*U.S. v. Southern Coal Corporation*, Civil Action No. 7:16-cv-00462-GEC

# Exhibit 5

## DECLARATION OF DANIEL LAWRENCE

**Supplemental Inspection Information**

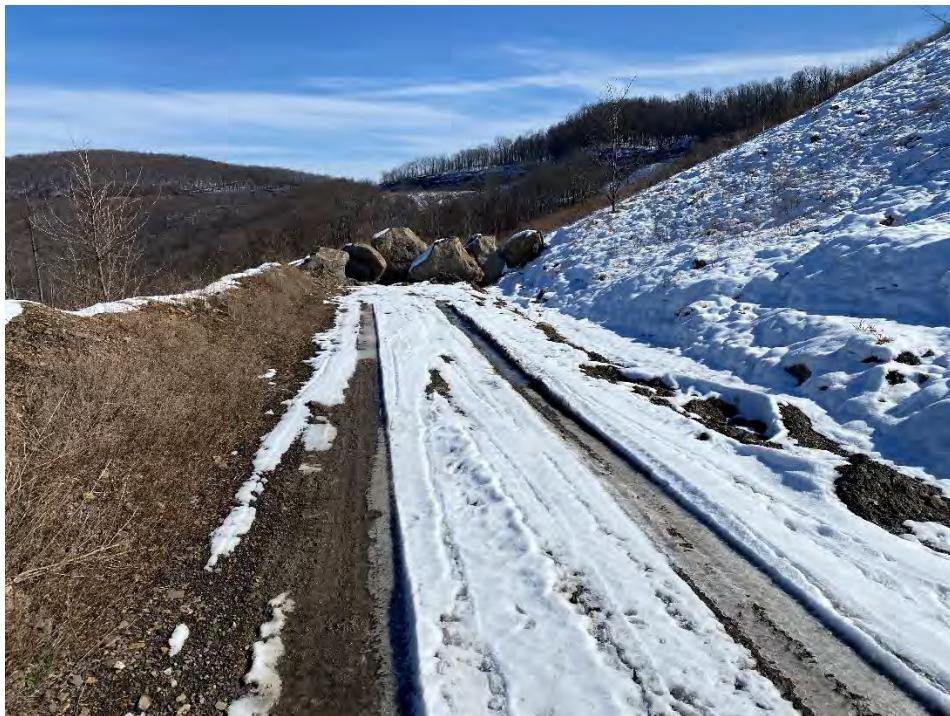
Mine 20 punch list items, as you can see in the pics Mine 20 still has quite a bit of snow, so hopefully these pics will work for now. The access road to pond 005 has water bars, (note: this 005 access road gets used to access a power line and gas wells also) and some of the water from the flat area above that was draining down to the 005 access road from the top, has been directed to the sump that was put in a while back for the stockpile area, and the water drainage and puddles in the pit area have been fixed for better drainage to drain to the pond 005 ditch, and the road has been blocked to try and prevent traffic from getting on the recently disturbed pit area.
